The issue of a proposed hydro-electric generating station in Bala remains complex, focusing on the issue of construction of an industrial facility in the heart of a recreation and tourist destination. Green energy versus green space.

Appendix A: Response to Proponent Letter dated October 30th, 2009

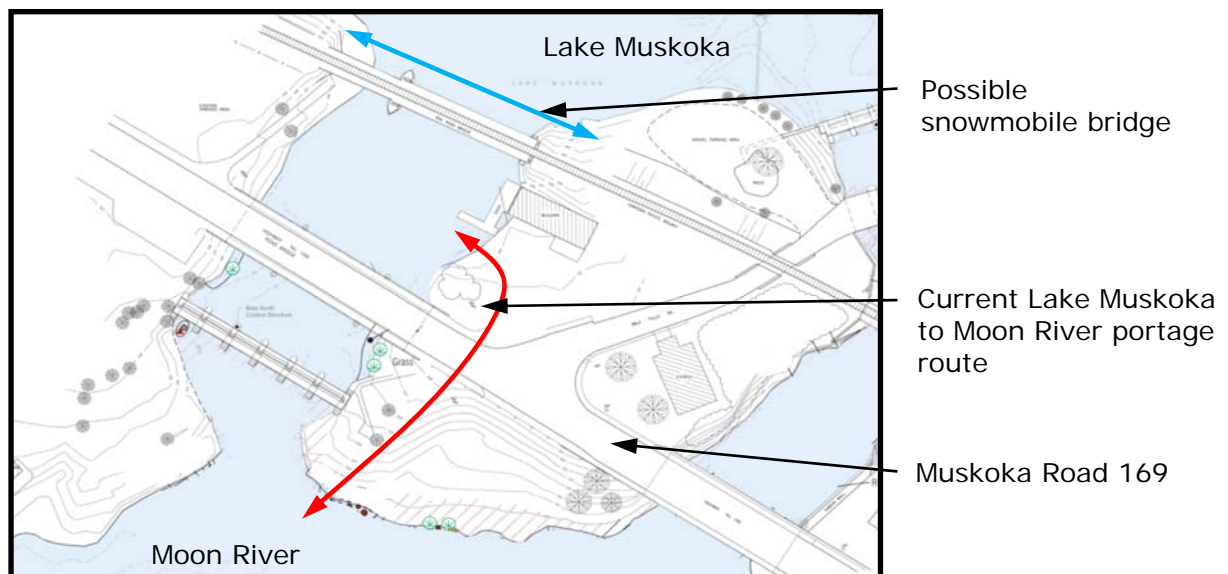
As stated, our concern relates to the water speed if one overshoots the town docks by a few feet. The boat would drift against the almost immediately adjacent safety boom and be held there, with danger increasing dramatically should one exit their boat. At this point the only rescue scenario identified by the proponent is to “ask the OPP”.

Given this significant public safety issue we would ask that DMM’s Staff Report include a specific review and evaluation of the steps required to get the power station shut down, the time required for this, the groups which would have responsibility to provide rescue services, and the training they would require.
